SERVICE BULLETIN

DATE: 15 APRIL 1981

FIELD INSPECTION AND REPAIR OF TAIL ROTOR TRANSMISSION MAIN HOUSING ASSEMBLY, PN 369A5401

Figure 2. Repair Bushing Fabrication and Installation Details

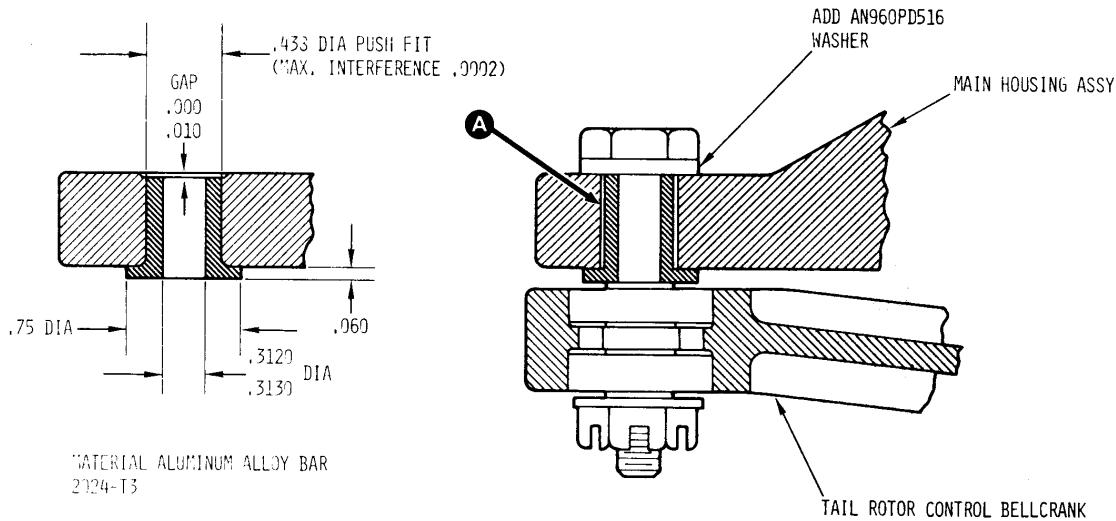
- k. Install transmission assembly on milling machine, and mill 0.060 inch from boss of main housing assembly. (See Figure 2.)
- l. Transfer transmission assembly to drill press or retool mill with 7/16 inch reamer or drill bit to correct elongated hole in support arm portion of main housing assembly.

- q. Fabricate aluminum bushing to comply with specifications provided in Figure 2.
- r. Wash bushing with MEK, and dry thoroughly.
- s. Immediately treat all surfaces of bushing with Turcoat Liquid Accelogold (this is a premixed, ready-to-use product conforming to military specification MIL-C-81706).

- t. Allow bushing to develop a gold color, then rinse thoroughly with water and dry.
- u. Coat bushing with zinc chromate primer and, while wet, insert it in newly enlarged hole in main housing assembly.

- v. Seal peripheral faying edges of bushing with PR1436-G, class B-2; PR14226, class B; PR1221; or MIL-S-81733, type II-2- sealant per manufacturer's instructions.

TORQUE NUT 100-140 IN.-LBS. ADVANCE NUT TO MEET HOLE AFTER REQUIRED TORQUE IS REACHED. WASHERS AS REQUIRED TO STAY WITHIN TORQUE LIMITS.

Figure 3. Main Housing Assembly Support Arm Hole Center Locating Diagram

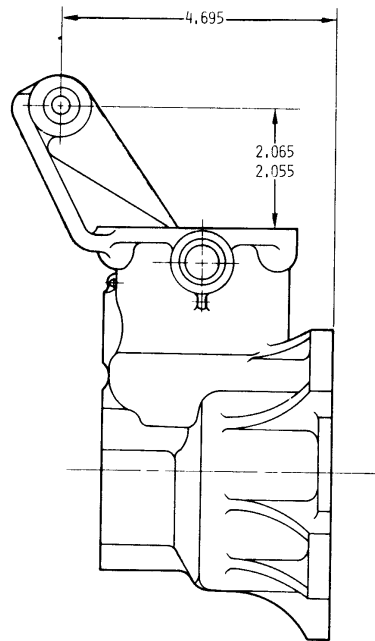
- m. Adjust transmission assembly so hole center in support arm will remain 4.695 inches and 2.065 to 2.055 inches from reference points shown in Figure 3.

- n. Ream or drill 0.438 inch hole.
- o. Remove transmission assembly from machining fixture, thoroughly wash oil and grease from all exposed magnesium surfaces, then dry.
